Subject: AIR INTAKE MODE DOES NOT WORK AFTER REPAIR OF RAIN SENSOR, FBCM, IC, PCM OR TCM	Bulletin No: 07-007/16
	Last Issued: 12/13/2016

2017 Mazda3 vehicles with VINs from JM1BN*****100087 to 100910 (produced before July 18, 2016)

2017 Mazda6 vehicles with VINs from JM1GL*****100017 to 103945 (produced before July 18, 2016)

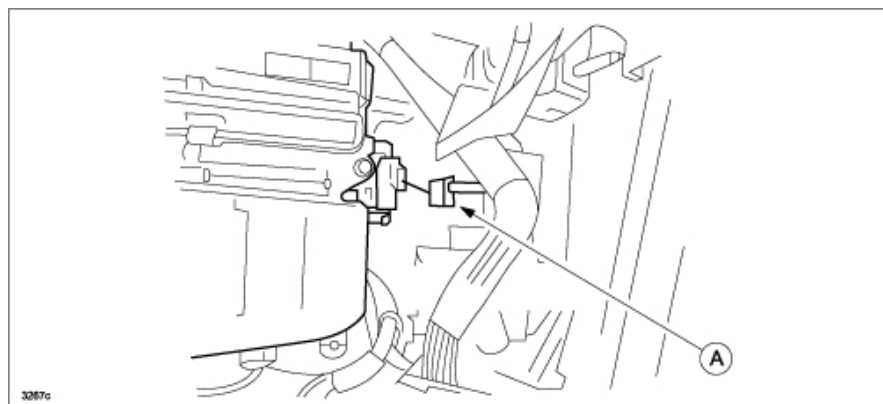
After performing any one of the following repairs, the air intake link at the blower unit may disengage and result in the HVAC system not switching between recirculation and fresh air modes.

This is caused by the air intake link in the blower unit not being sturdy enough for the actuator torque under fail safe mode. Fail safe mode occurs when a communication error occurs between the A/C control unit and the humidity sensor. To correct this problem, the blower unit has been modified. (Part number has not been changed.)

- Do not turn the ignition on until all wirings/connections have been completed when replacing rain sensor, FBCM or IC.
- Before starting to reprogram the PCM, TCM etc. (vehicles with manual A/C only), disconnect the air intake actuator connector (A) at the blower unit. After reprogramming is finished, turn the ignition off, connect the actuator connector, and then confirm proper operation.

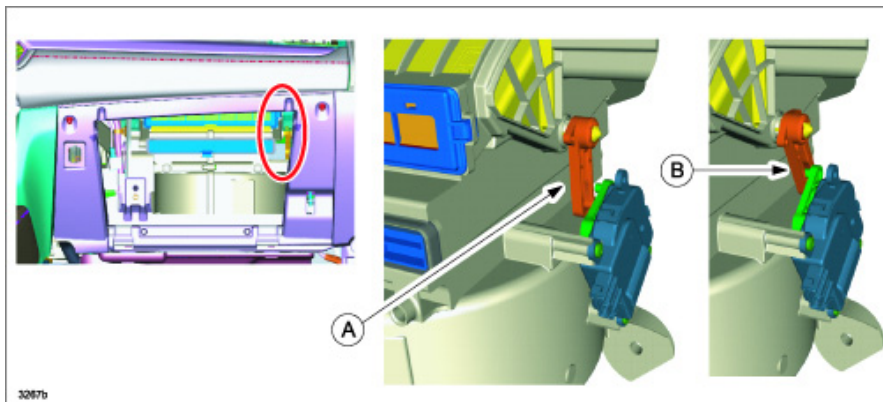
NOTE: If the date code (YYYY/MM/DD) on the blower unit is the following date or later, it is already modified.

Date Code: Mazda3 - 2016/07/11, Mazda6 - 2016/07/12
